Technical Service Information

FORD E4OD SLIDE/BUMP 1-2 UPSHIFT 1997 MODEL ONLY

Figure 1

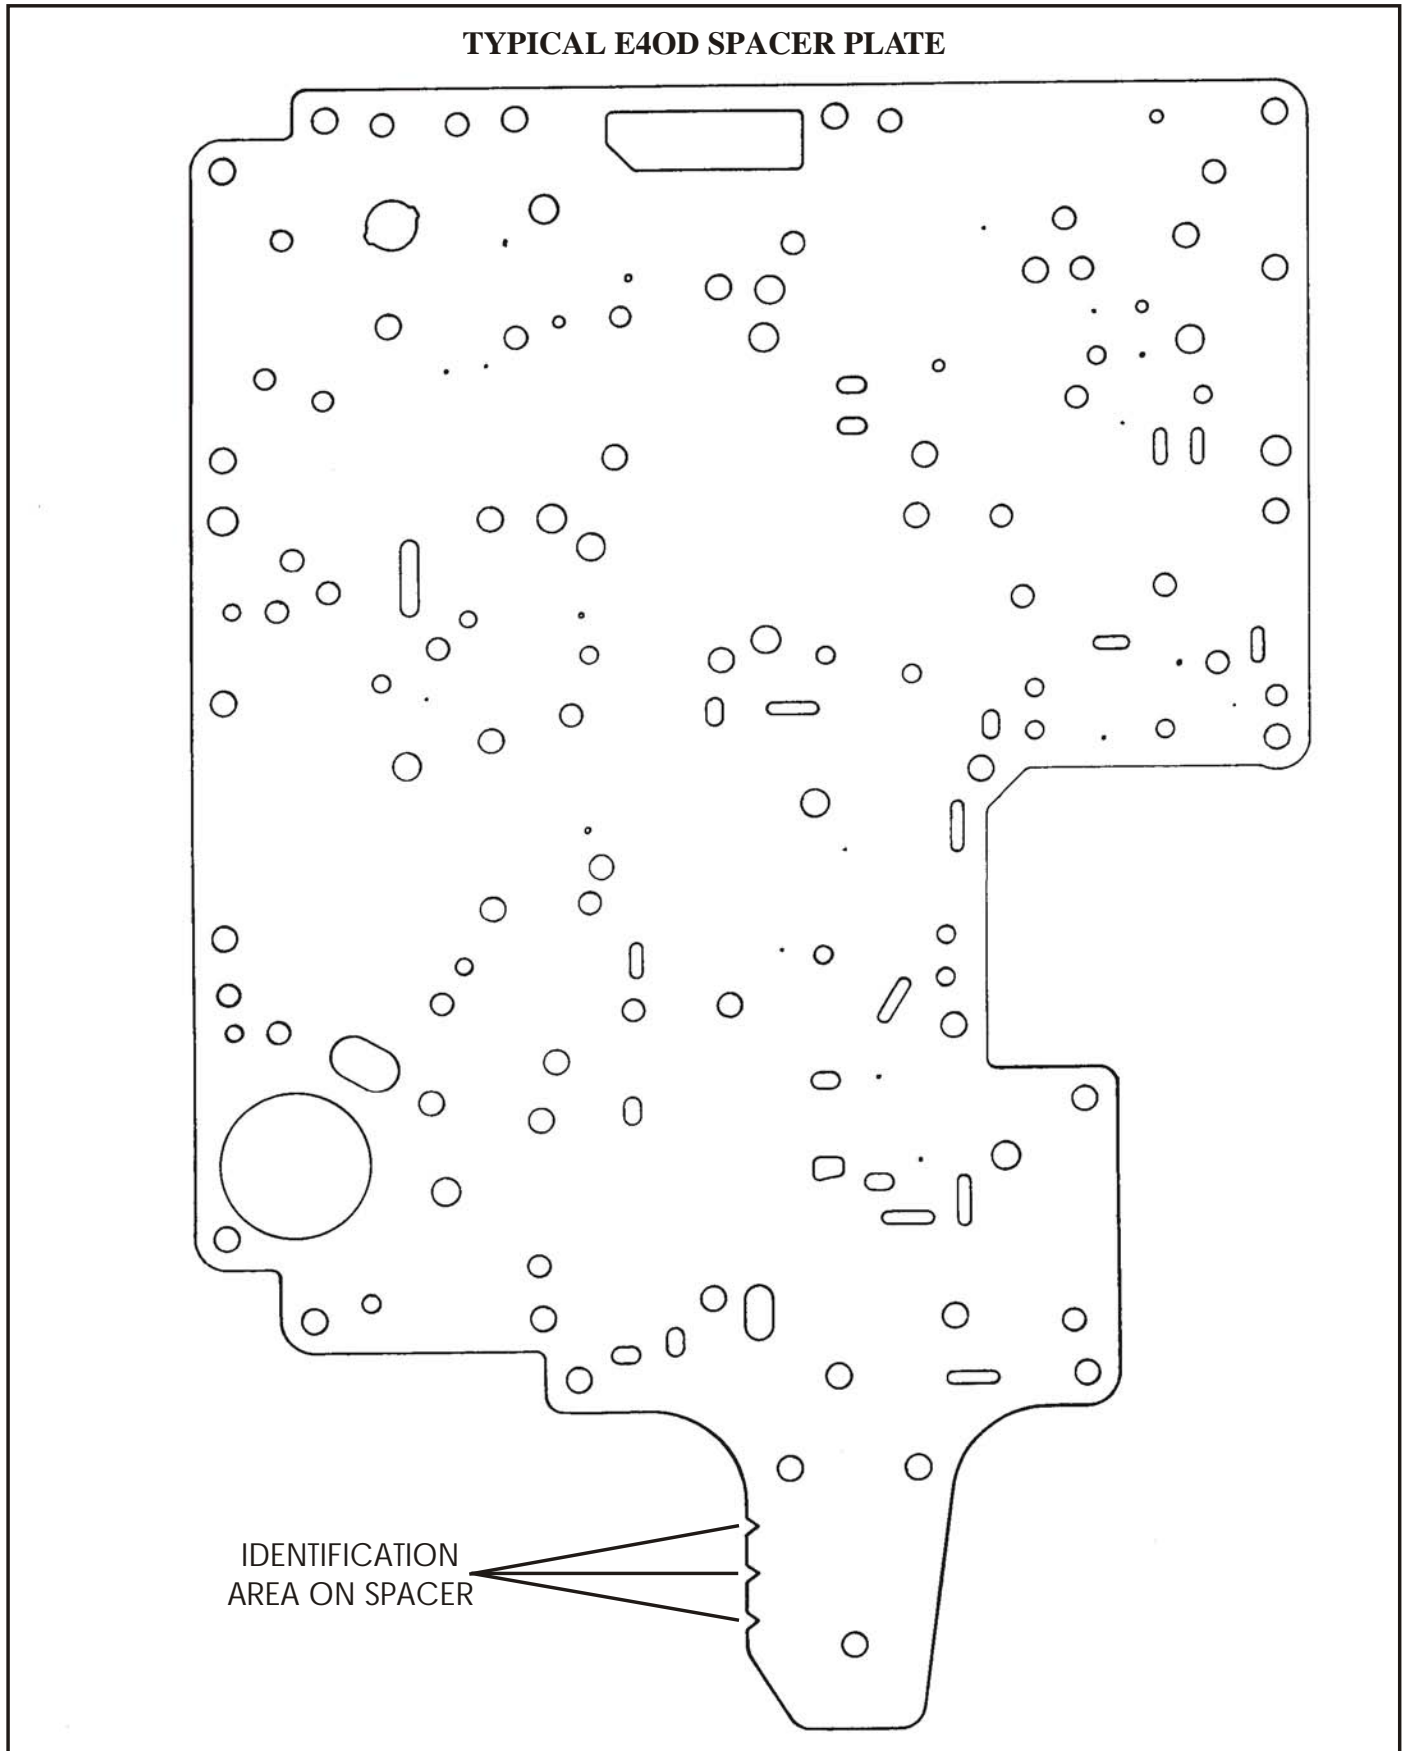
COMPLAINT: Some 1997 models of the Expedition and the F-150 Trucks may have a soft/drawn out and/or slide/bump 1-2 upshift, on models built from 4/18/97 through 4/21/97, and the transmission build date is 7D15 with serial numbers between 00012500 and 00012855.

CAUSE: The cause may be, the transmission being built with the wrong valve body spacer plate.

CORRECTION: Once confirmation has been made that you have a suspect transmission that falls between the build dates and serial numbers listed above, remove the pan and inspect the spacer plate identification stamped into the "tail" of the plate. Figure 2 shows the location of the identification notches, and the chart in Figure 1 below shows the 1997 spacer plate identification that is wrong. Install new spacer plate F7TZ-7A008-AA, along with new valve body gaskets.
